Subject: **Request for Modification of Section 404 General Permit No. 198200031 and Section 401 Water Quality Certification, and lifting of Notice of Violation Status** for the Interstate 85 (I-85) widening and interchange improvements from north of NC 73 to north of SR 1280, Cabarrus and Rowan Counties, Divisions 9 and 10. Federal Aid Project No. NHIMF-085-2(61)55, TIP I-3802A.

The North Carolina Department of Transportation (NCDOT) requests modification to the existing General Permit No. 198200031 and associated Water Quality Certification for widening and interchange improvements along I-85 in Cabarrus and Rowan Counties. This project is currently under construction.

Revisions have been made to seventeen impact sites and are discussed in detail below. Two new impact sites are also discussed below (Site 36 and the Troutman waste site).

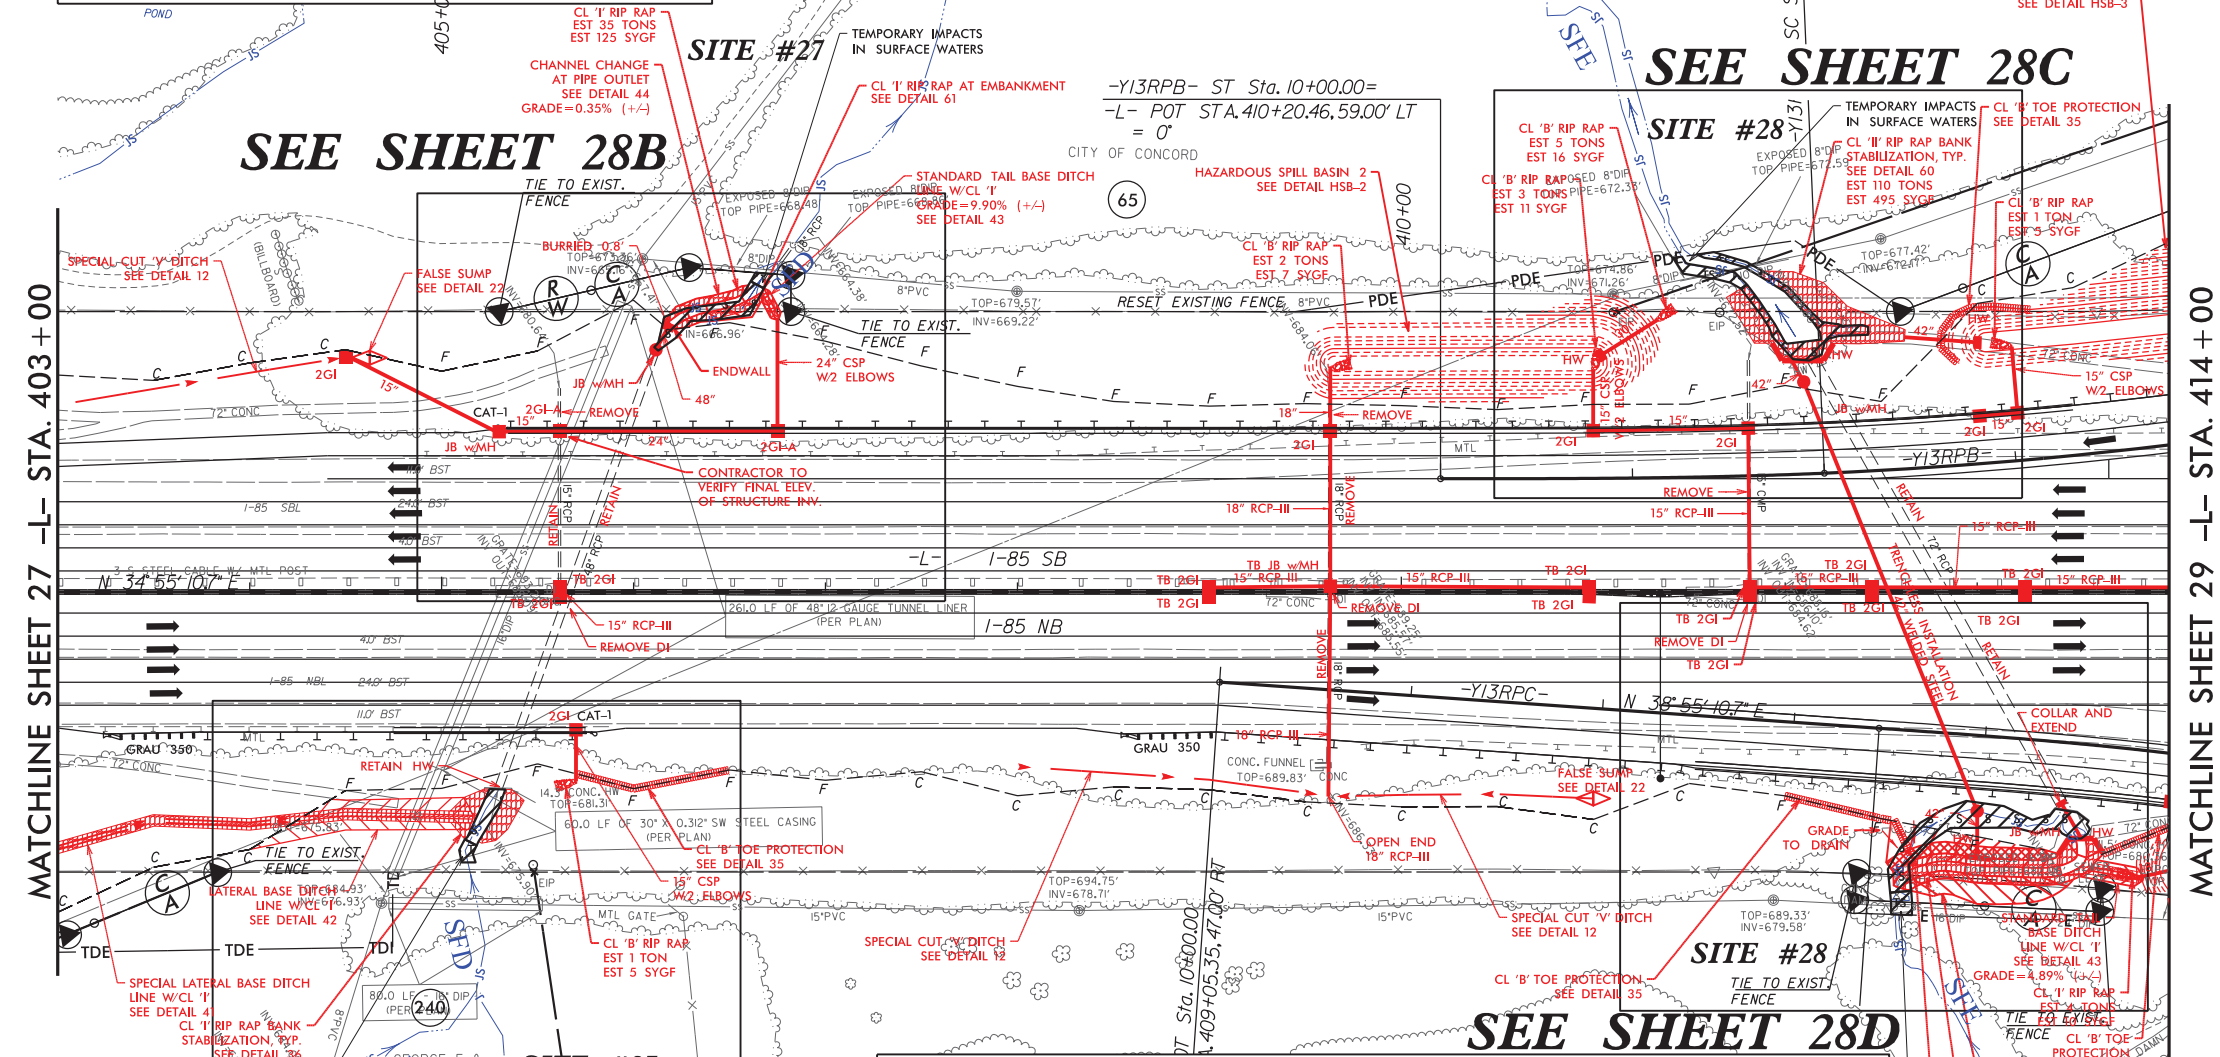
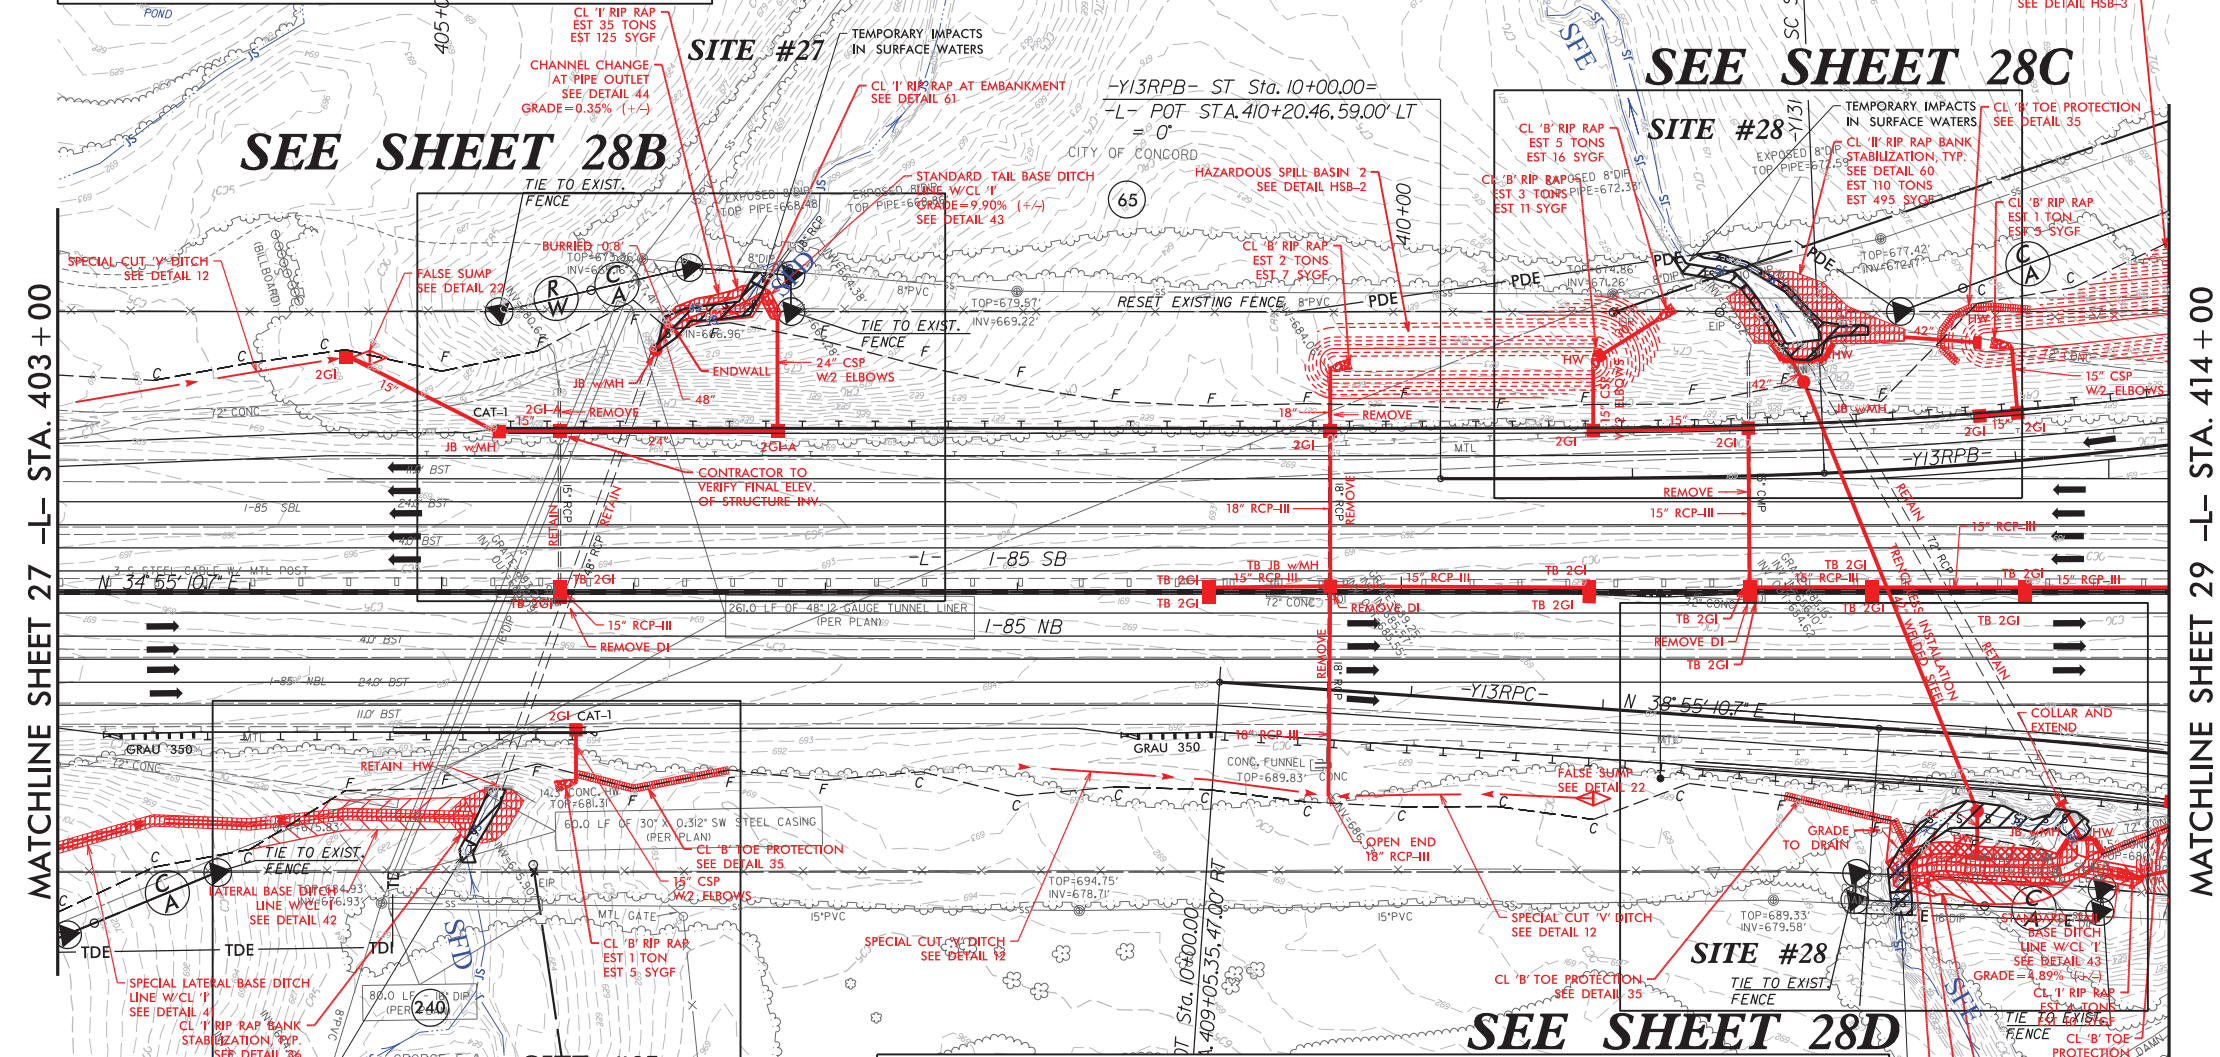
Site 28 (Sheet 28) – To provide additional stabilization, Class II rip rap was placed in the bed of the channel change for stream SFE on the upstream end of the crossing and existing channel bed downstream. Stream bank stabilization impacts decreased from 73 linear feet to 44 linear feet, which is 29 linear feet of less impacts. Permanent stream impacts decreased from 119 linear feet to 116 linear feet, which is 3 linear feet of less impacts. Temporary stream impacts increased from 29 linear feet to 58 linear feet, which is 29 linear feet of additional impacts.

Site 27 (Sheet 28) – Field measurements conducted after construction indicated changes in impact quantities. Permanent stream impacts to stream SFD were reduced from 70 linear feet to 64 linear feet, which is 6 linear feet of less impacts.
